INDESIT company

Model type:
WITL86EU

Commercial code:
F034263

1140960 Exploded views

n1040345: Replacement of drum lock button TL EVOII.

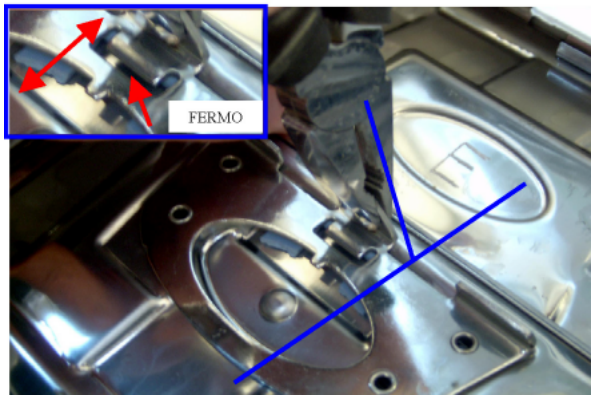
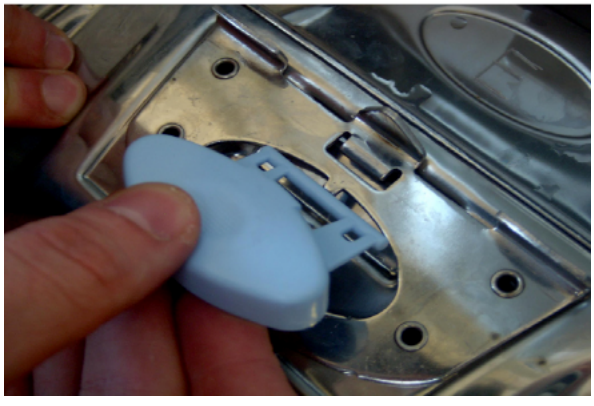
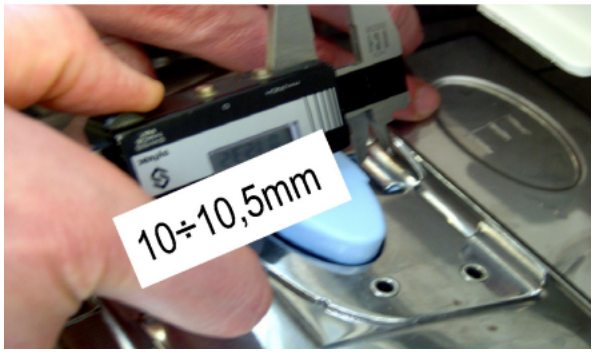
Tools and material needed: pliers, screwdriver, gauge, spring P/N Sat 114989, button P/N Sat 114990.

1) turn the central tip of the catch in the direction shown (FIG.1);

2) bring the tip to a vertical position and ensure that the broken button is disengaged from the catch restraint and can be removed (FIG.2);

3) remove the remaining part of the button with the aid of a screwdriver, taking care not to scratch the doors (FIG.3);

4) pre-assemble spring to button (FIG.4);

5) insert button between catch and door (FIG.5);

6) bring the button into position and arrange the spring in its location in the door (FIG.6);

7) turn the central tip of the catch in the direction shown to return it to its starting position (FIG.7);

8) check the distance between button and catch (FIG.8);

9) check correct operation of the button when opening and closing the doors (slight inclination errors of the catch can result in faulty closing of the doors) (FIG.9).

n1040382: Drain pump with bayonet-style filter - top Loading Brembate

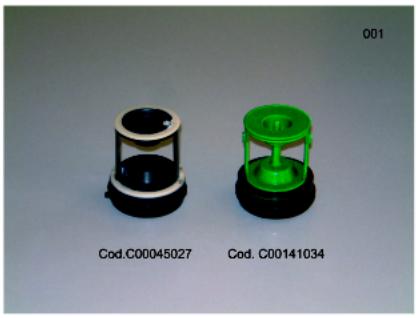
From serial no. 51021.0001 a new drain pump with bayonet-style filter has been installed on all top loading washing machines manufactured in Brembate.

New parts:
C00141862 - Drain pump
C00141034 - Pump filter kit

Premodification parts:
C00111409 - Drain pump
C00045027 - Pump filter kit

The new parts can be used instead of premodification ones.

N1040404FIG1

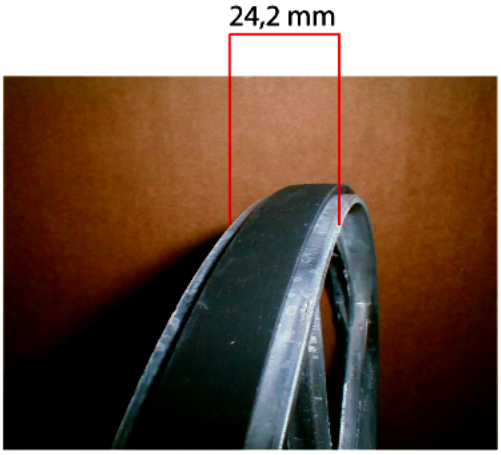
n1040404: New pulley installed on top loading washing machines up to 1000RPM (NO tub lock)

From serial no. 51202.0001 the pulley track has been widened from 21.2mm to 24.2mm (see picture N1040404FIG1).

new pulley
C00142832 - D280 24.2 mm track

Premodification pulley
C00083912 - D280 21.2 mm track

The new pulley can also be used on premodification versions of the models referred to in this release.
